Addendum #2

Attn: Estimator	Date: November 26, 2024
From: Lisa Donahue, Project Administrator	Pages: 25 (including cover page)
Re: Bullock Creek School District 2024 Bond Series 1	Project: 2025 Summer Projects HS/MS/Elem/Pine River/Floyd and Maintenance Building
CC:	Proj. #: A24907

ADDENDUM #2

Project: No. 24-120 2023 Bond – Series 1 2025 Improvements

DRAWING TITLE		
ELECTRICAL PLAN		
SEAL	DRAWN FLA	PROJECT NO. 24-120
	CHECKED RCH	CAD FILE NO. A-E000
	REVIEWED RCH	DRAWING NO. F-E102
	DATE OCT 18, 2024	SHEET NO. 13 OF 13
	SCALE AS NOTED

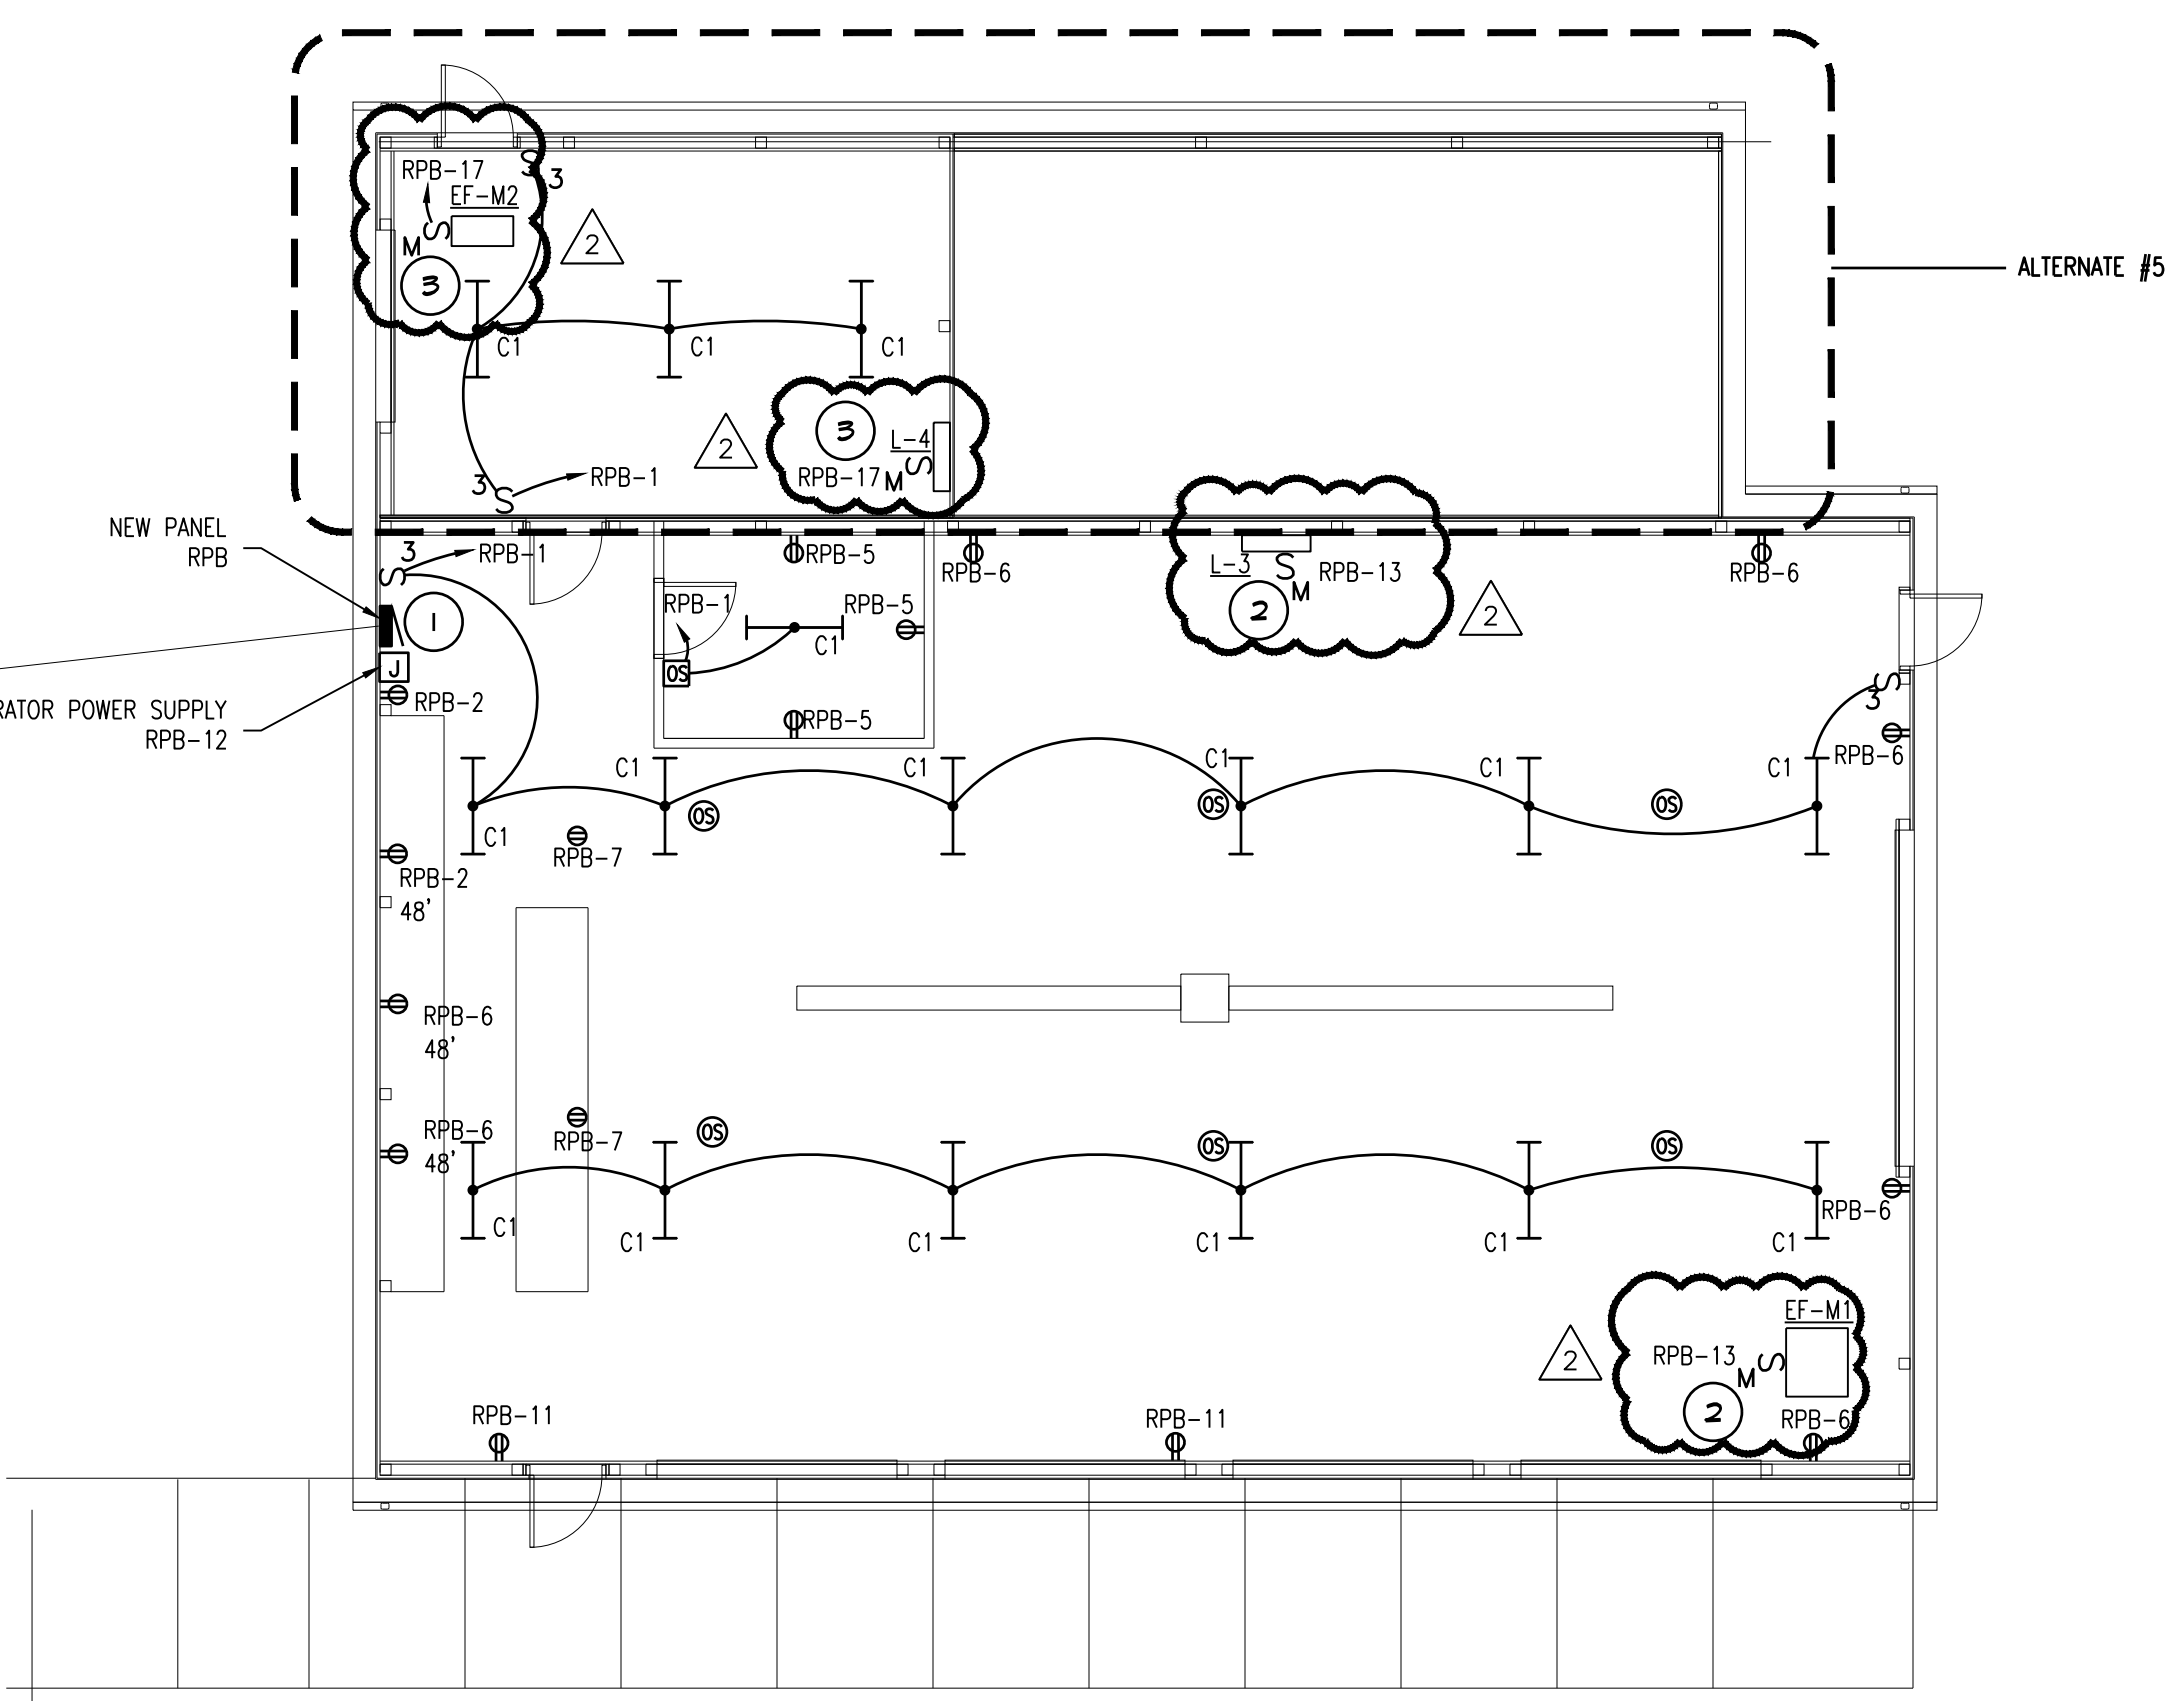
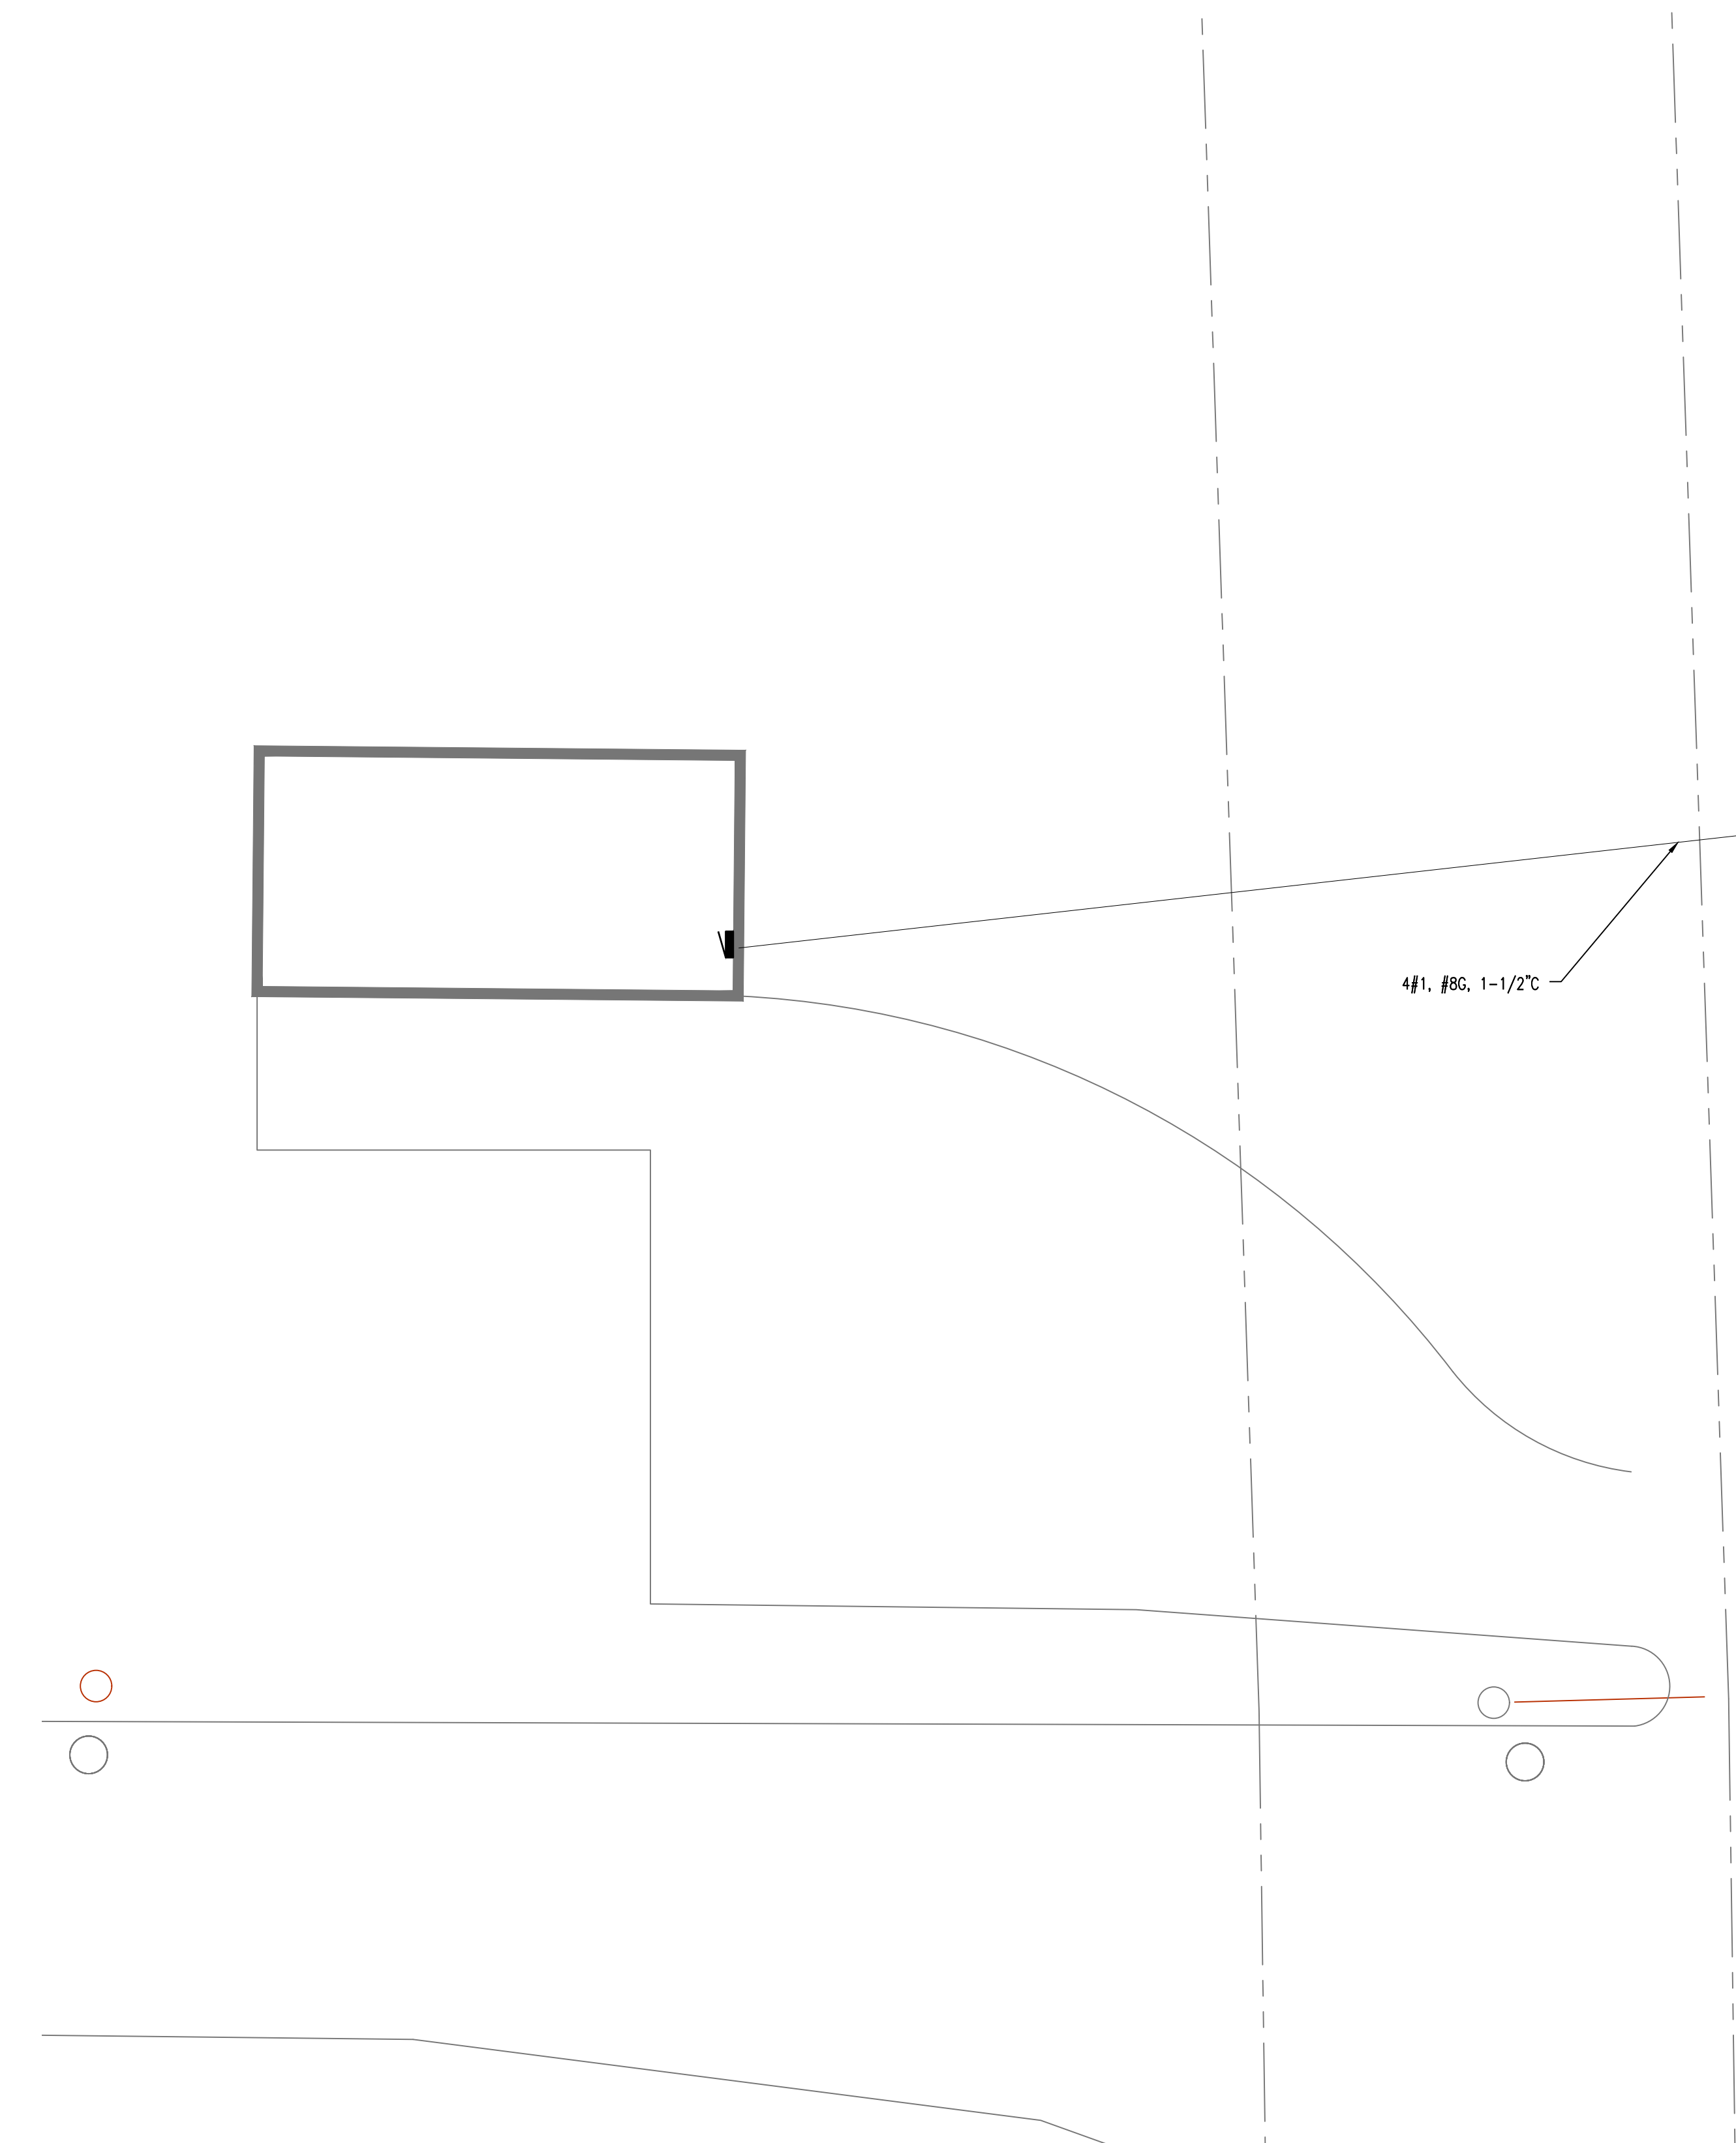
- Item #E1: Revise Sheet F-E102 as follows:
- a. Provide electrical connections to exhaust fans.
